To: T10 Technical Committee
From: Tim Symons, PMC-Sierra (Tim_Symons@pmc-sierra.com)
Date: 5 July 2007
Subject: 07-307r1 SAS-2 Zone group valid bit

Fix for SAS2r10 Editors Note 11

Figure 51 — One ZPSDS example

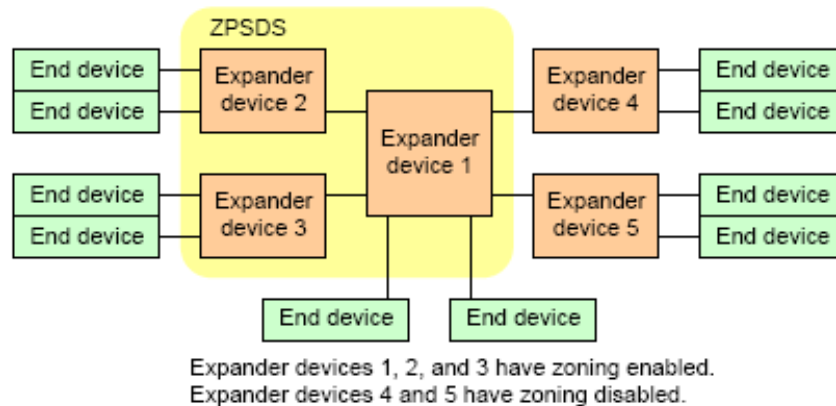
The zone route table of a zoning expander device may contain SAS address entries with the ZONE GROUP VALID bit set to zero. e.g. The zone table entries for SAS addresses of end devices attached to expander devices 4 and 5 shown in figure 51, do not have valid zone groups, because they are not attached to zoning expander devices.

The zone group of the phy on the boundary of the ZPSDS shall be asserted as the zone group for SAS addresses with the ZONE GROUP VALID bit set to zero
